RENEWABLE SOLAR POWER PROJECT BY ADANI

Project Title	Renewable Solar Power Project by Adani
Version	02
Report ID	A+SH_SYST_TQC_VCS_VER_1422

Report Title	Renewable Solar Power Project by Adani
Client	Adani Renewable Energy (RJ) Limited
Pages	42
Date of Issue	08-July-2022
Prepared By	LGAI Technological Center, S.A. (Applus+ Certification)
Contact	Campus UAB – Ronda de la Font del Carme, s/n 08193 Bellaterra – Barcelona (Spain) Tel: +34 93 567 20 08 Fax: +34 93 567 20 01

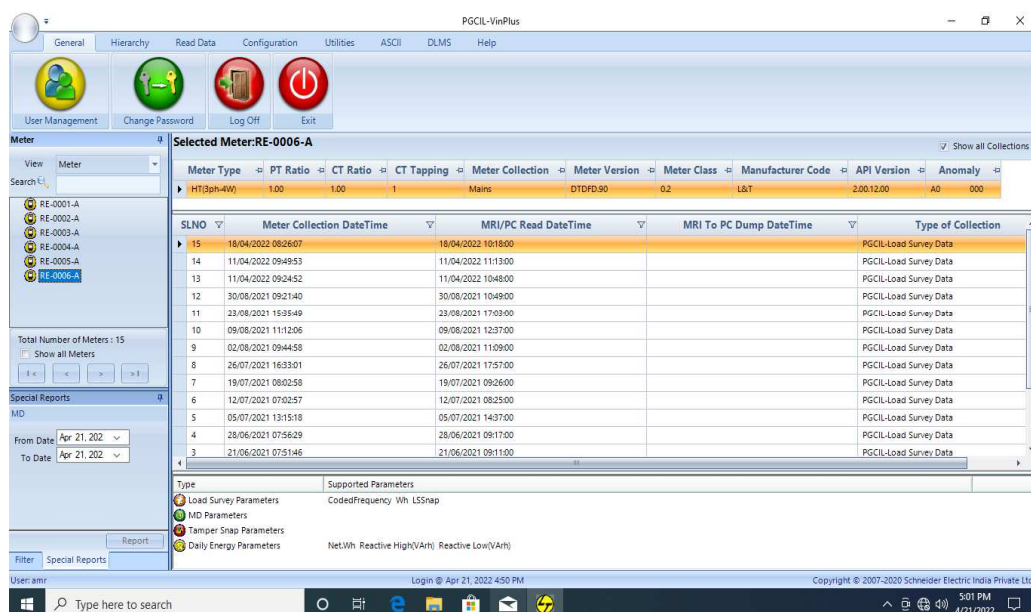
PP has requested deviation for change in meters in monitoring plan being the aforesaid meters at the PGCIL substation are beyond the control of Project Proponent because they are owned and operated by PGCIL and PP does not have any role in their calibration and monitoring of data.

The meters locations have been verified with SCADA page which shows 6 No. of meters. These meters are the source of data for all Energy Accounting of the project activity. These have been installed at project end and the PP has access to them for collection of data and calibration as well.
